Lr. No. RPP-SM-JV/RRW/457

Project: Major up gradation of Raipur Railway Station of SECR on Engineering Procurement and Construction (EPC) mode.

Subject: Re-Submission of Architecture Definitive Drawings for the Rear side Station Building 1-A.

Vide ref AE's Lr No: TL-PMS/RPPS/240 dt 10-05-2025, we are re-submitting Definitive Drawings for the Rear Side Station Building 1-A.

SITE PLAN

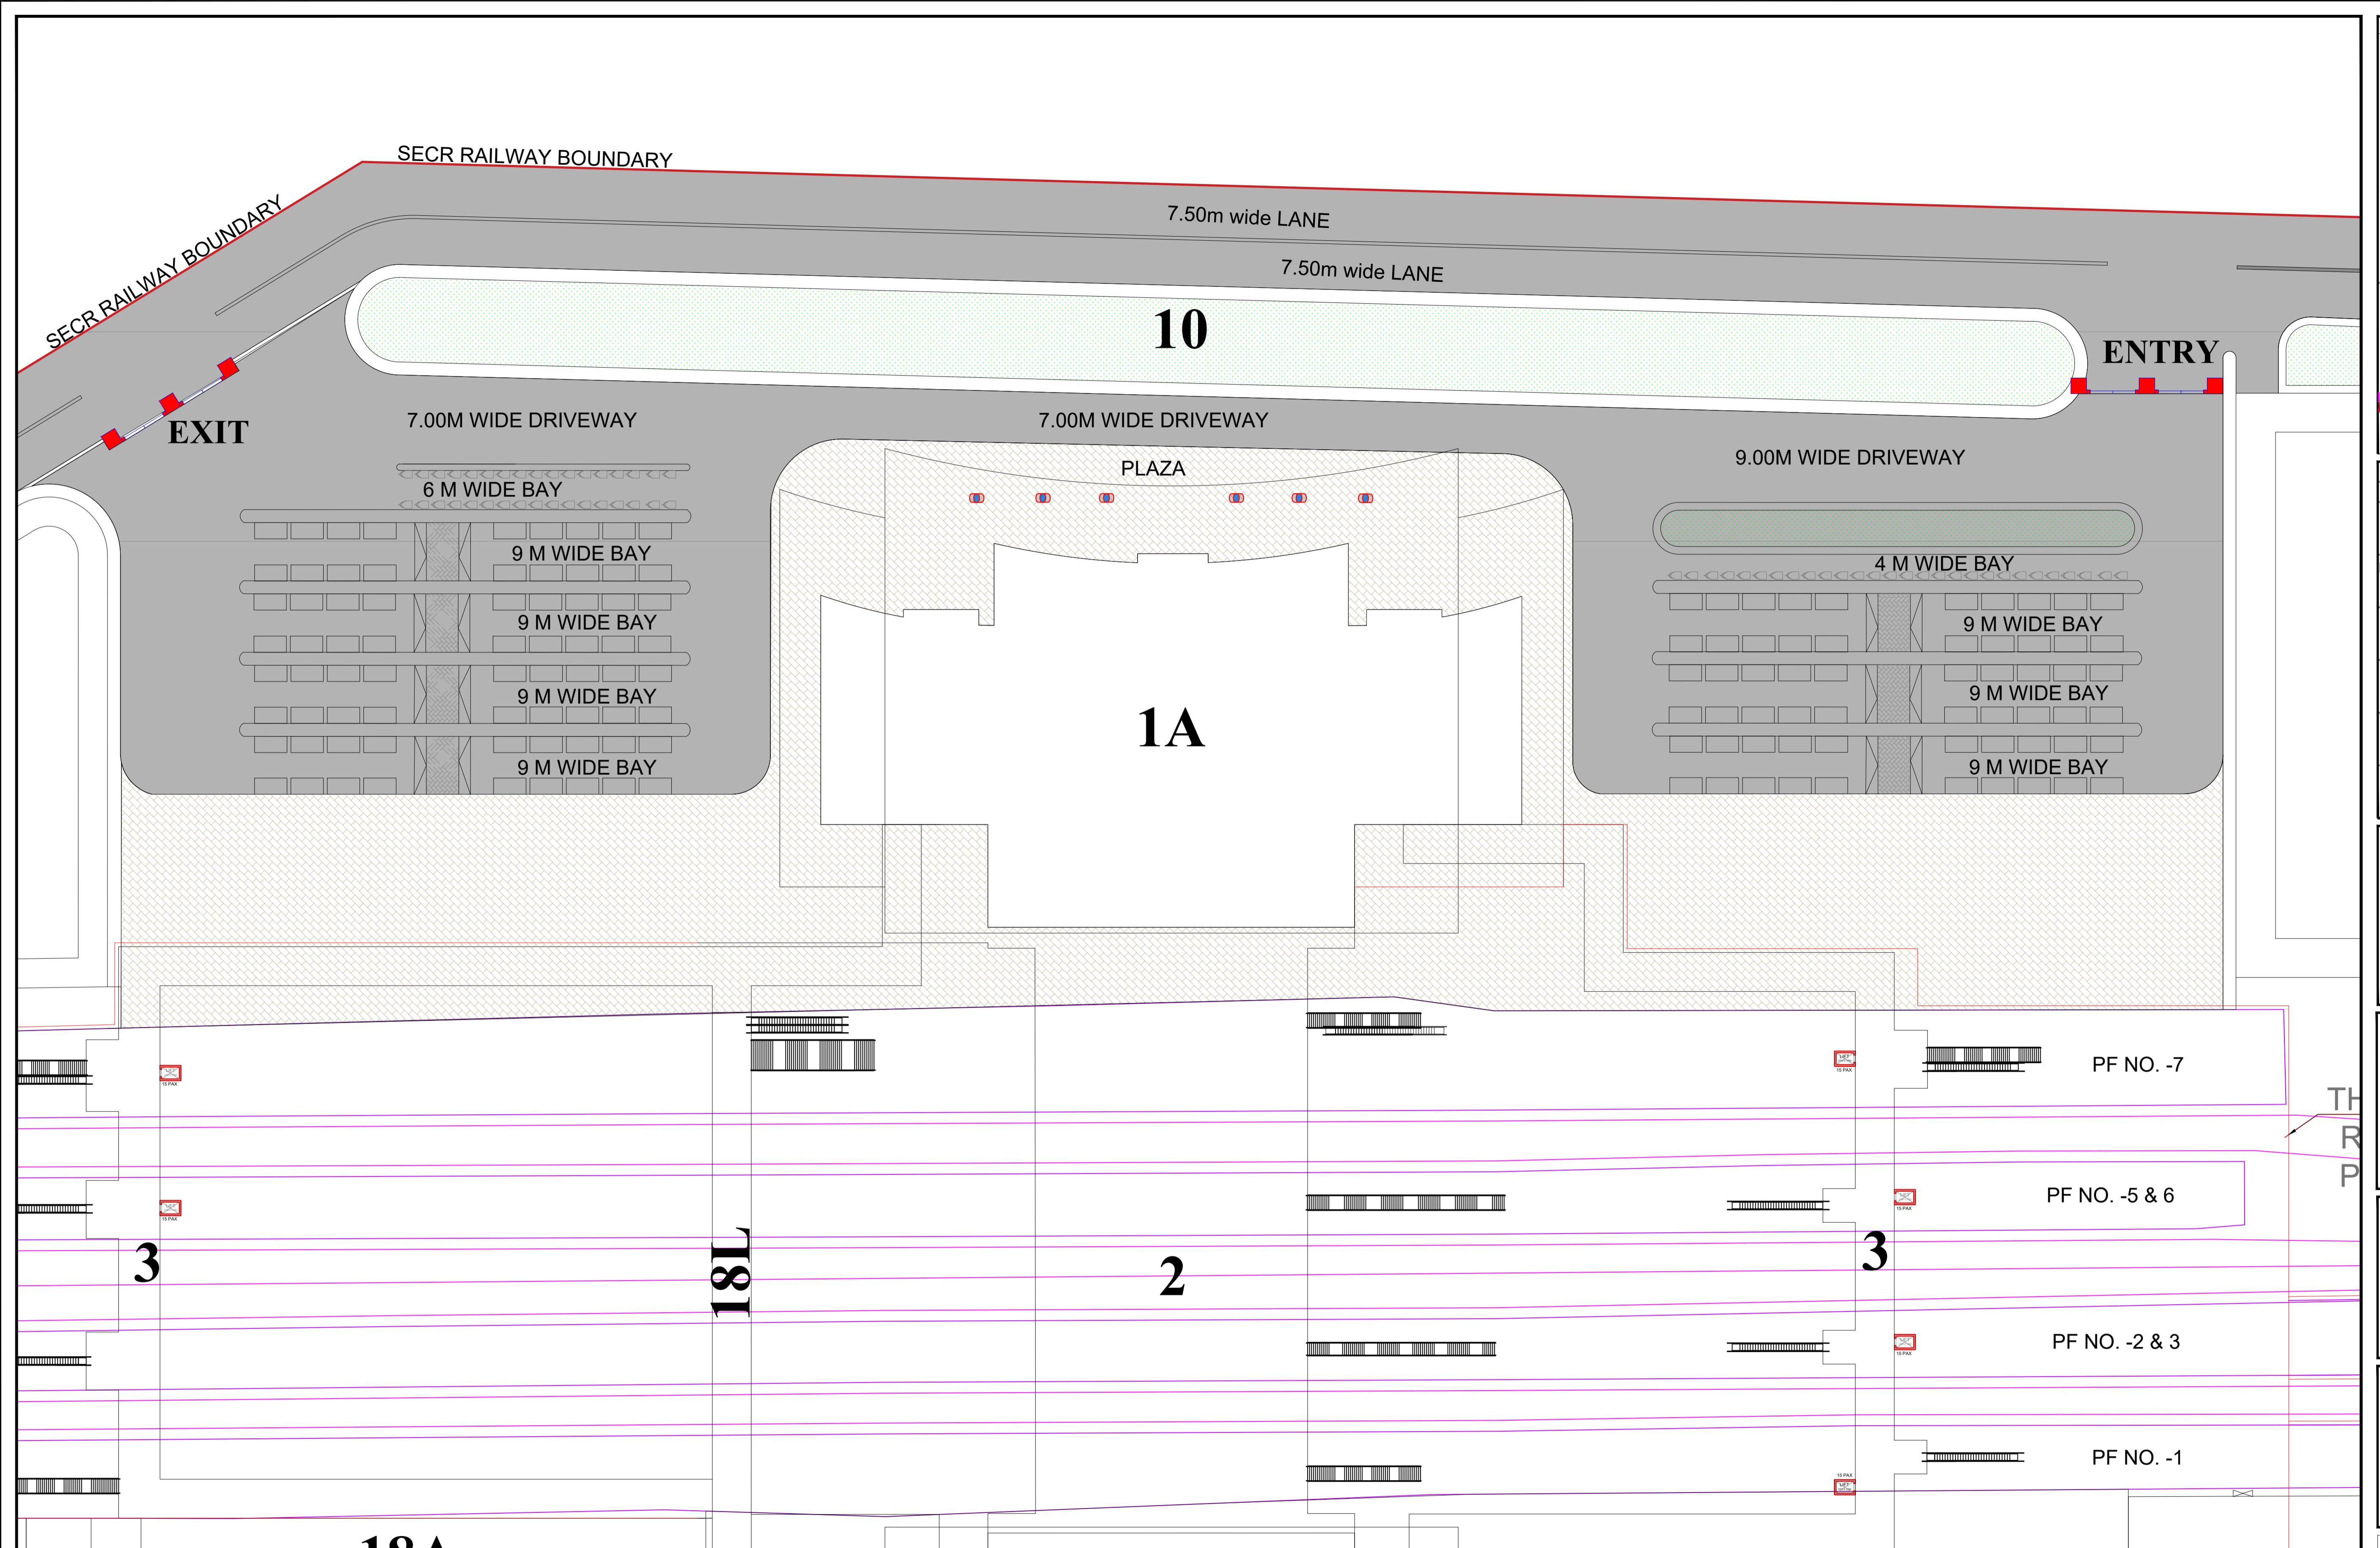
j. Do provide site plan, location plan, terrace level plan and mumty level plan.

REPLY: We have added site plan, location plan and roof plan. There will be no terrace plan and mumty plan as we will be having truss roof.

FIRST FLOOR PLAN

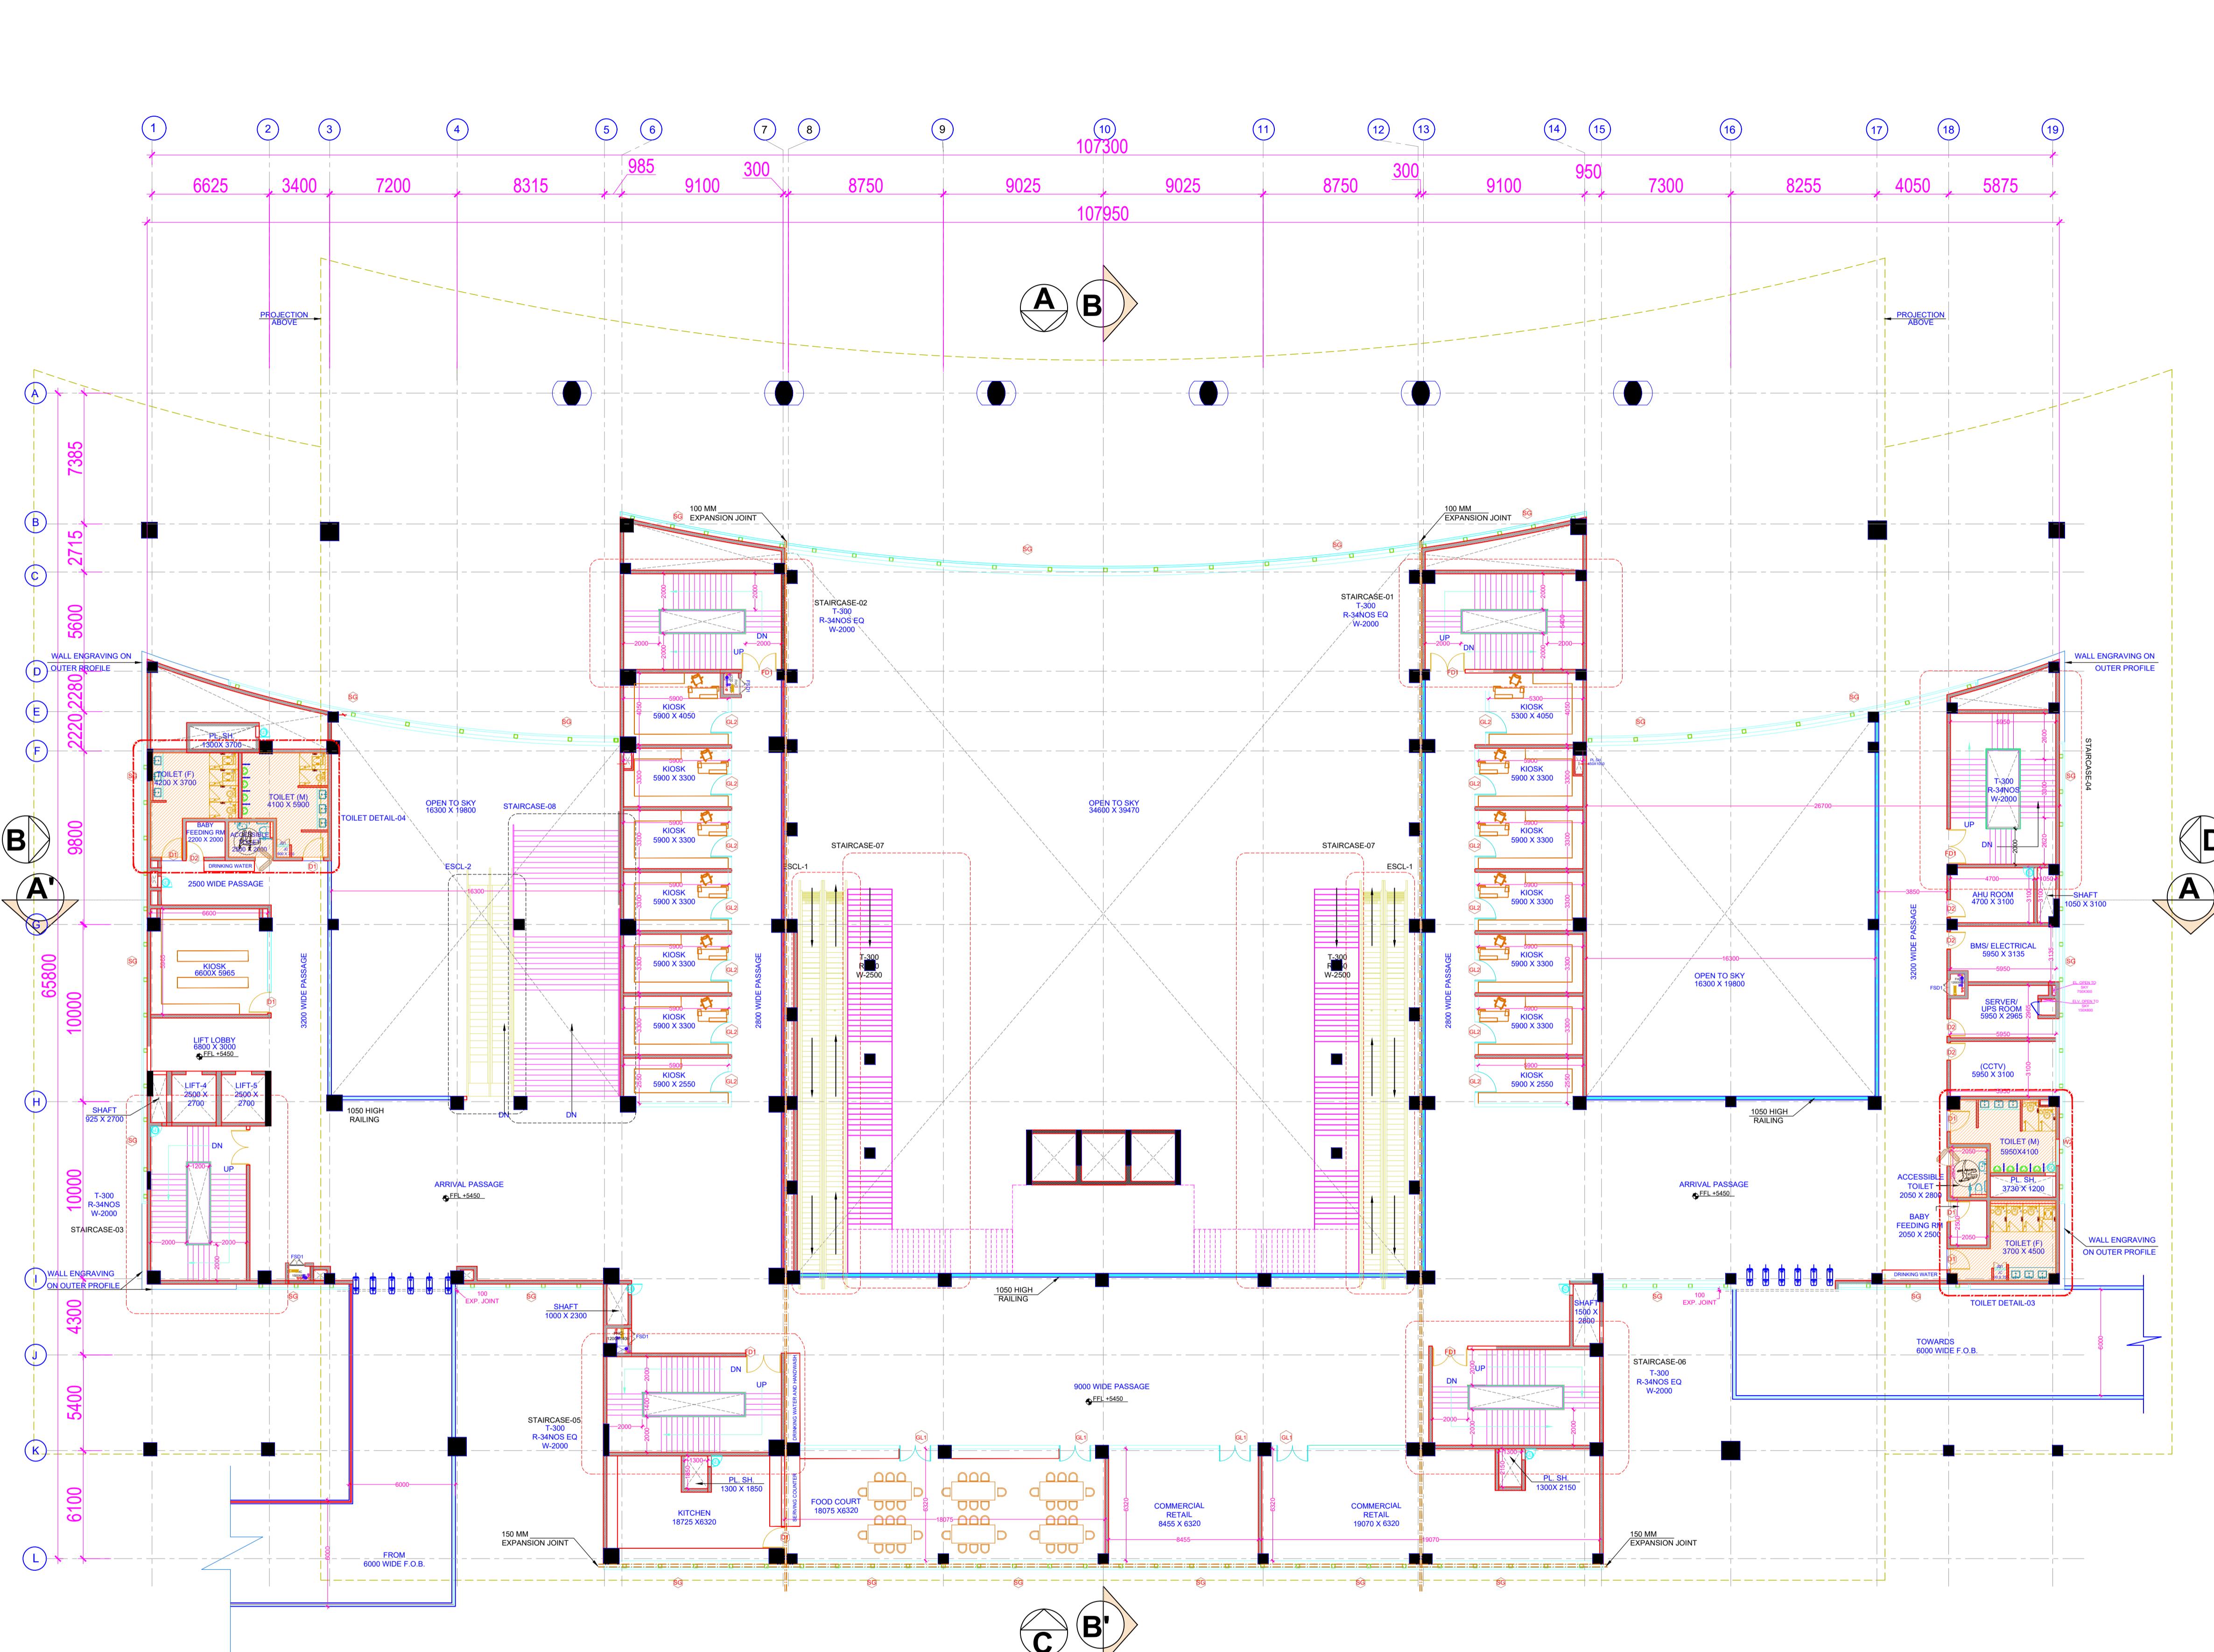
ll. In first floor on grid no. Y6 – X1, shaft wall to be merged with toilet wall to avoid negative space.

oo. In first floor, do check requirements of kitchen, wash area and drinking water for food court.

REPLY: Yes, we have already incorporated the same

REPLY: Yes, we have already incorporated the same.

SECTION A

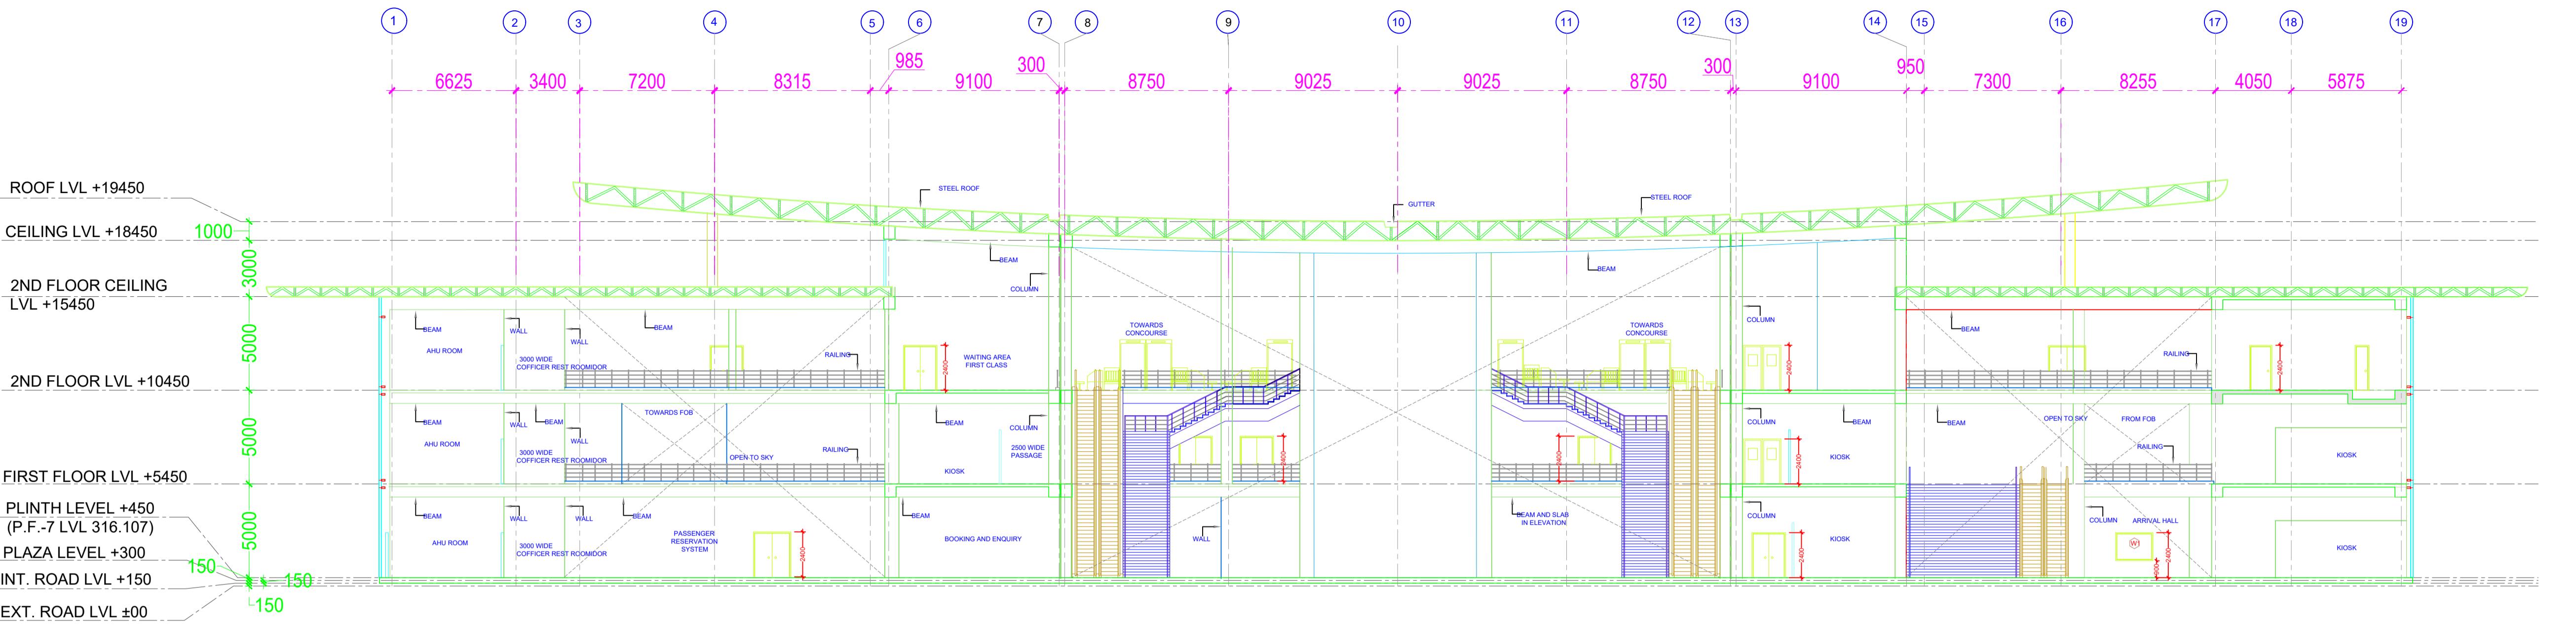
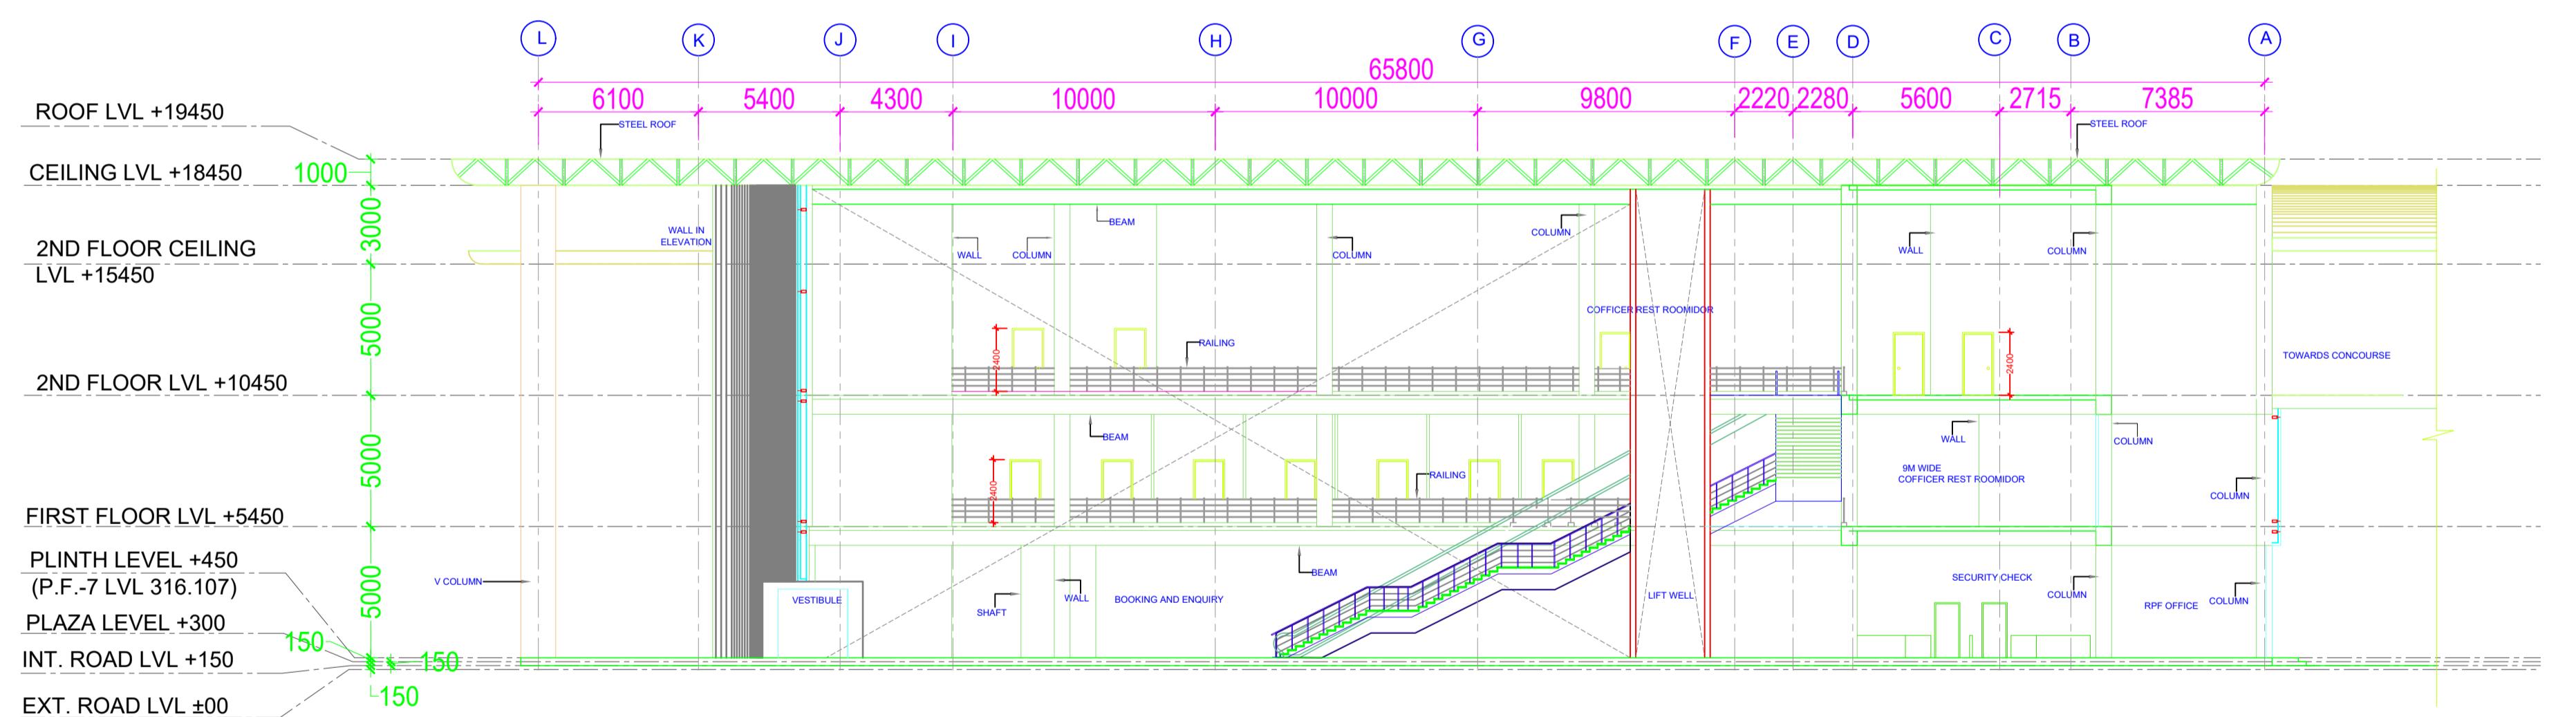
vv. Do provide vertical dimension of opening in section.

REPLY: Yes, we have already incorporated the same.
